GREENLANDS NATIONAL GALLERY OF ART
GRØNLANDS NATIONALGALLERI FOR KUNST

INVITED DESIGN COMPETITION
INDBUDT PROJEKTKONKURRENCE

JURY REPORT FEBRUARY 2011
DOMMERBETÆNKNING FEBRUAR 2011

37 | GREENLANDS NATIONAL GALLERY OF ART **ENTRY 5 TEGNESTUEN NUUK**

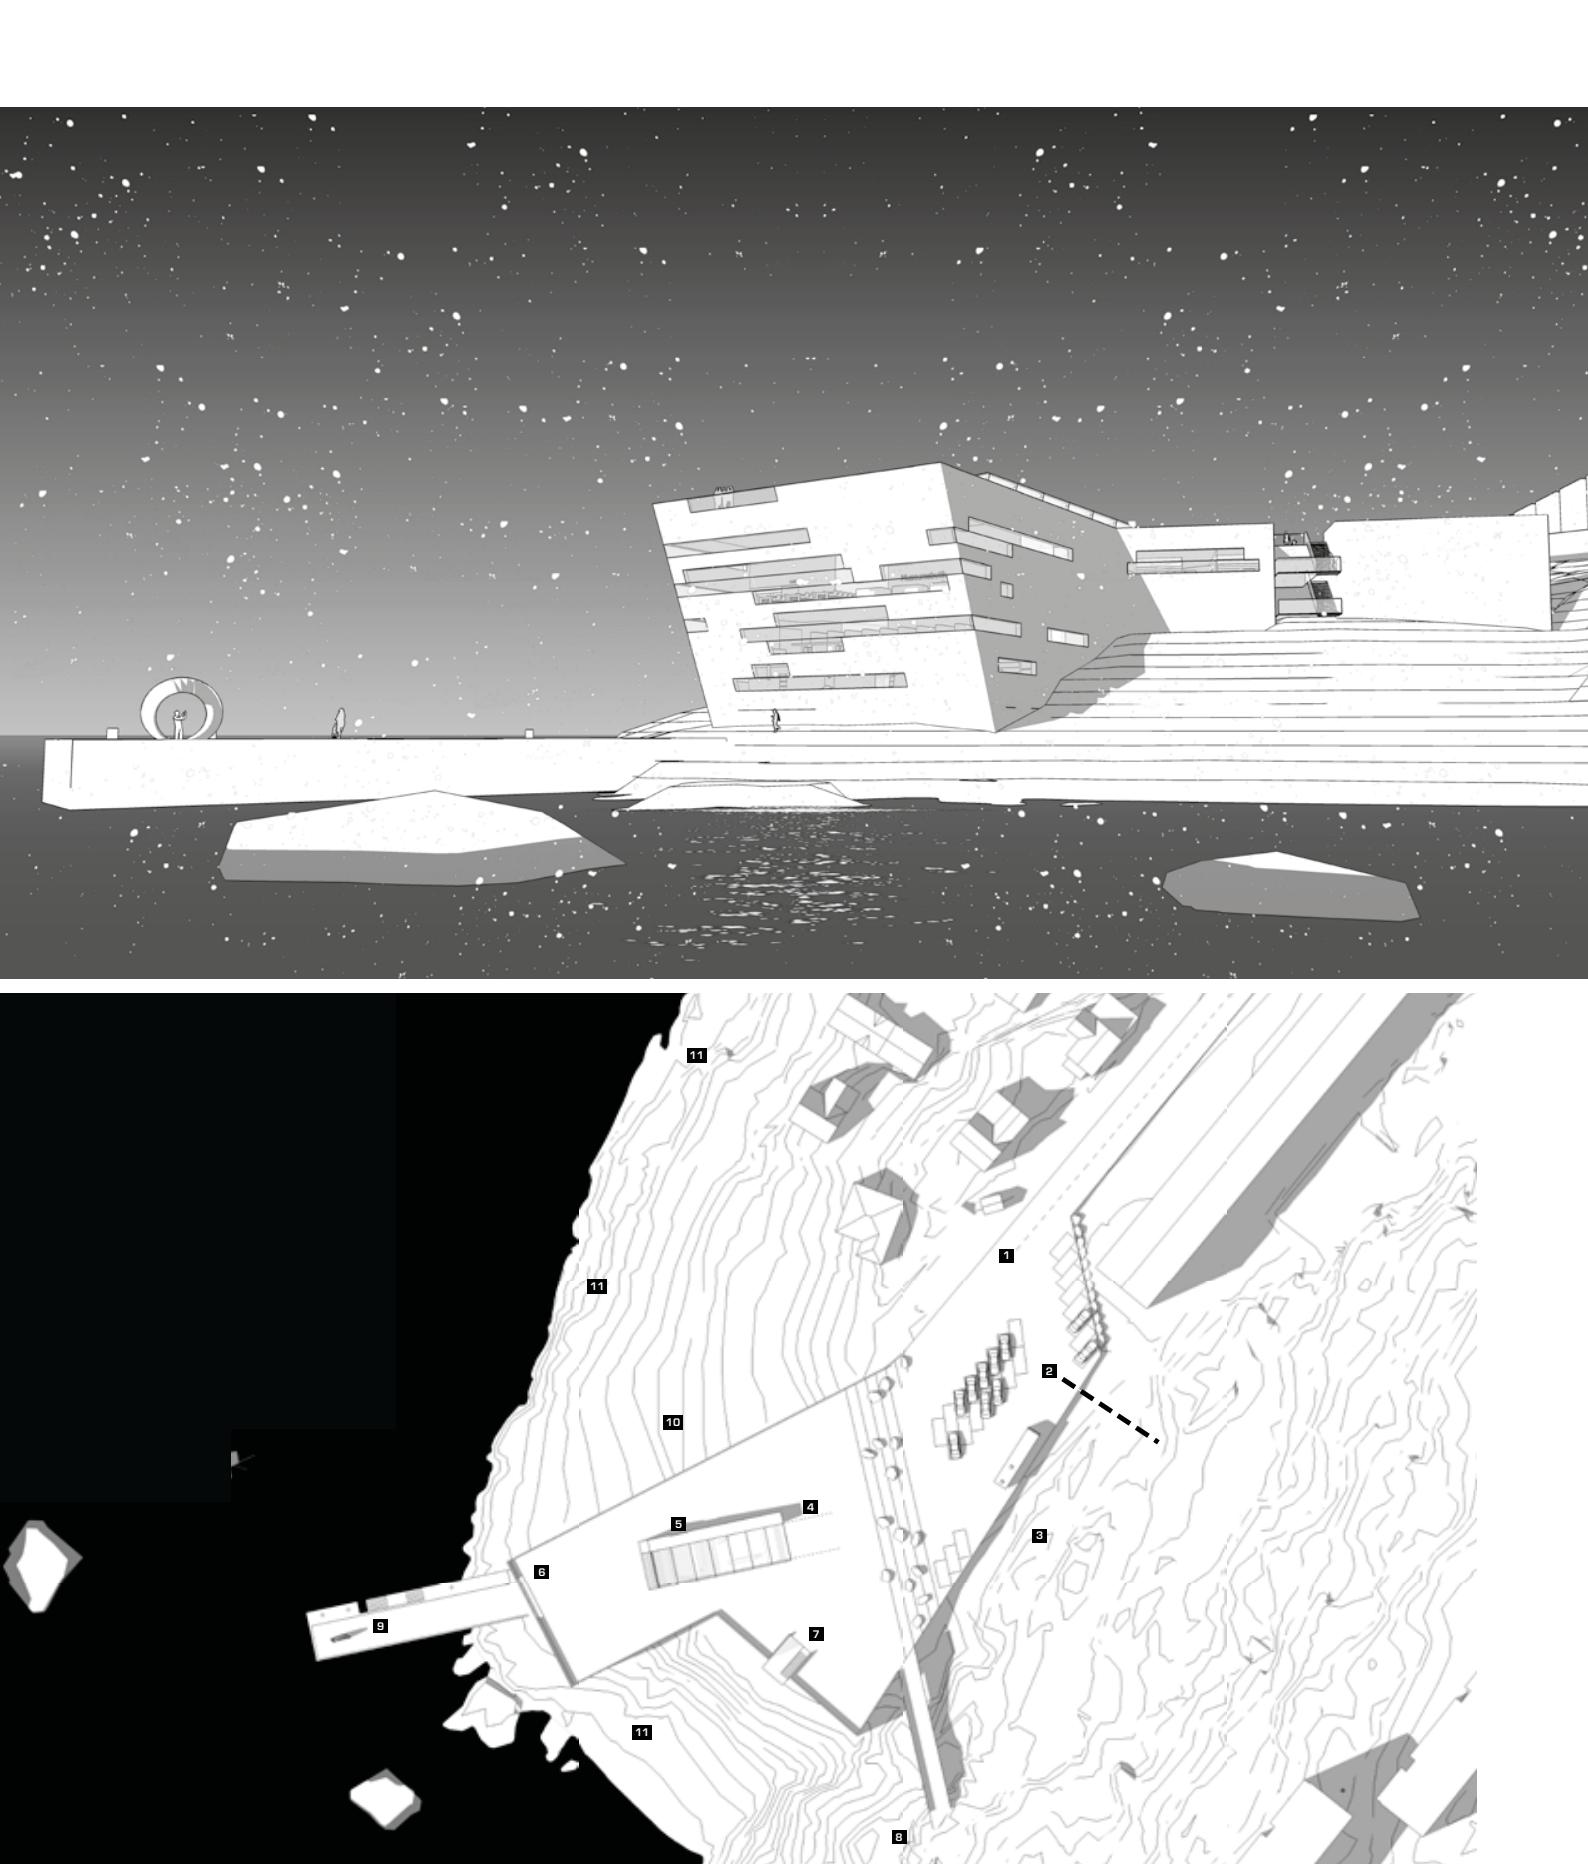
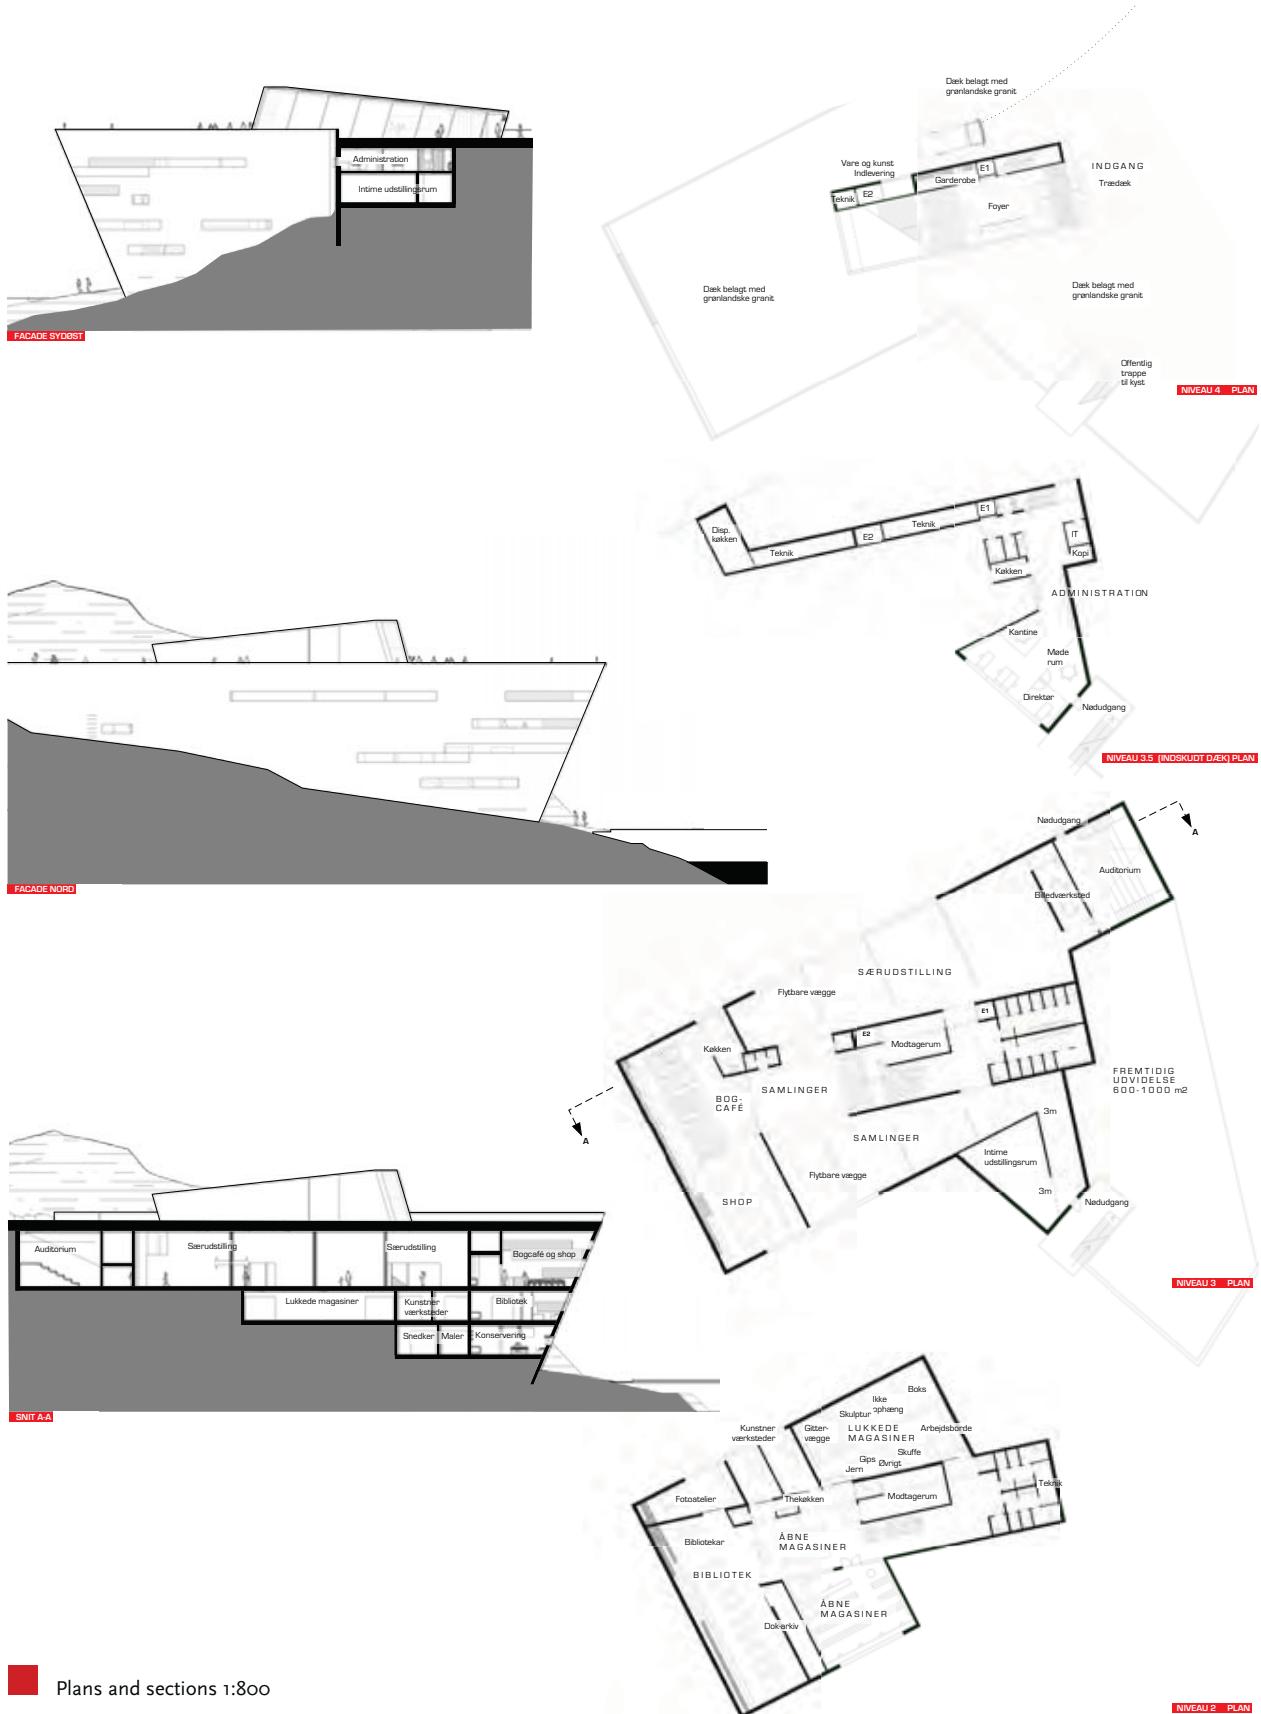
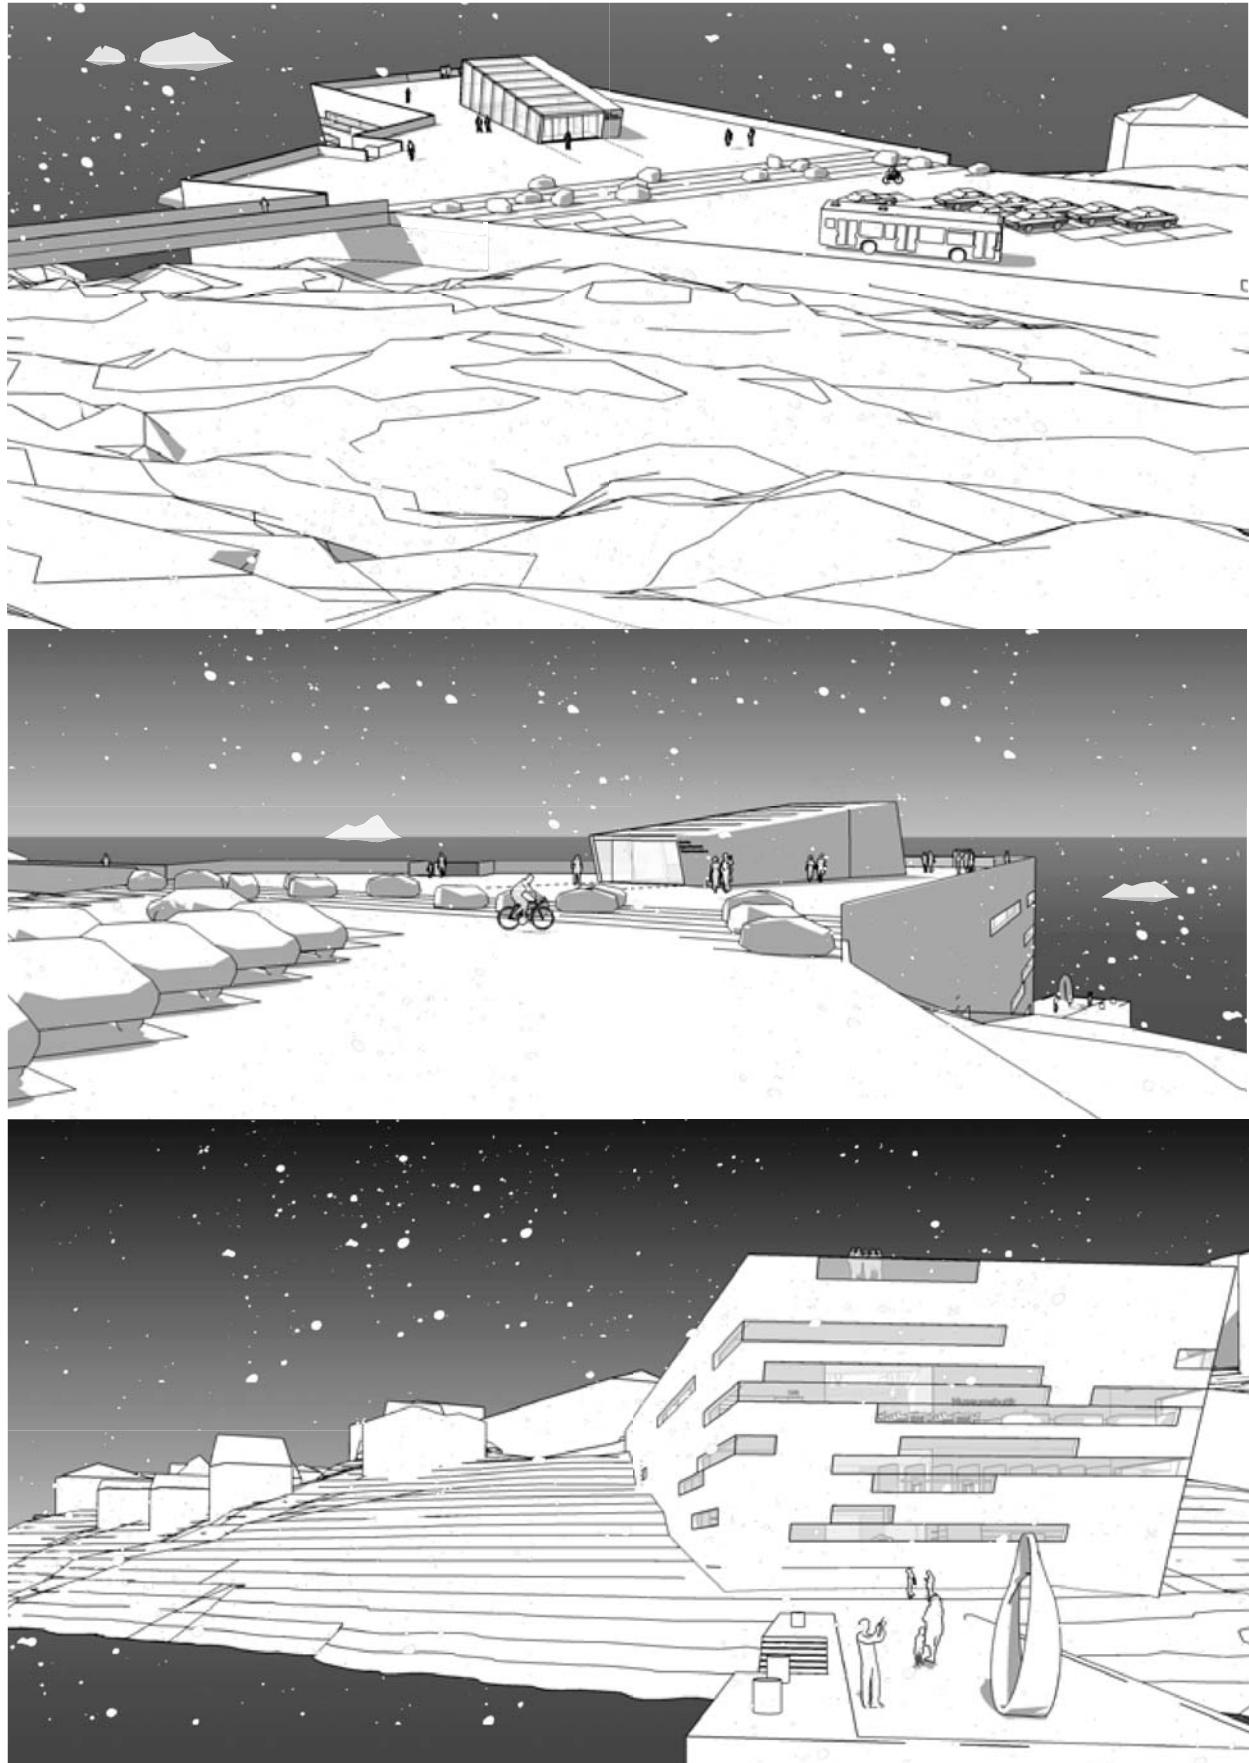
The facades of the base are clad in timber, with horizontal ribbon windows while the 'public square' – i.e. the building's roof – is laid in local granite. The timber cladding lacks credibility in terms of the style and impact of the proposal.

The exhibition rooms are good and versatile but the awkward angles in the geometry of the house are not plausible or appropriate for exhibitions of sculpture. In general, the remaining areas work well, with good daylight conditions and scope for views out to sea.

Nuuk sympathetic, but does not judge that the work on this idea achieved a coherent building. The flights of stairs attracted particular criticism, occupying as it does too much space without adding genuine functional value; the auditorium being separated from the café was also a flaw.

This proposal describes a building with outer walls, central corridors and suspended floors in cast-in-situ reinforced concrete. The concrete structure of the building envelope is externally insulated in order to minimise cold bridges and is finished in timber cladding.

The proposal specifies briefly that heating and cooling will be provided by "bedrock heat" which it states should be "the most normal means of heating in the Scandinavian countries". The building is sited such that the roof surface is flush with Tuapann-guit's street level, with vehicular access passing over the roof level.

No detailed provision is made for unrestricted driving of heavy vehicles on the roof slab; nor does the roof height take account of the requirements of the Building Regulations for a minimum roof pitch of 7 degrees.

The design proposes what is a bastion facing the fjord, with a jetty for seaborne approach, a main body and adjacent terraced grounds close to the waterline of the fjord. However there is no provision for the problem posed here by tidal variation (water levels rising to up to 4-5 metres). The proposal involves vertical load-bearing structures, so is judged to be viable in terms of structure and stability.
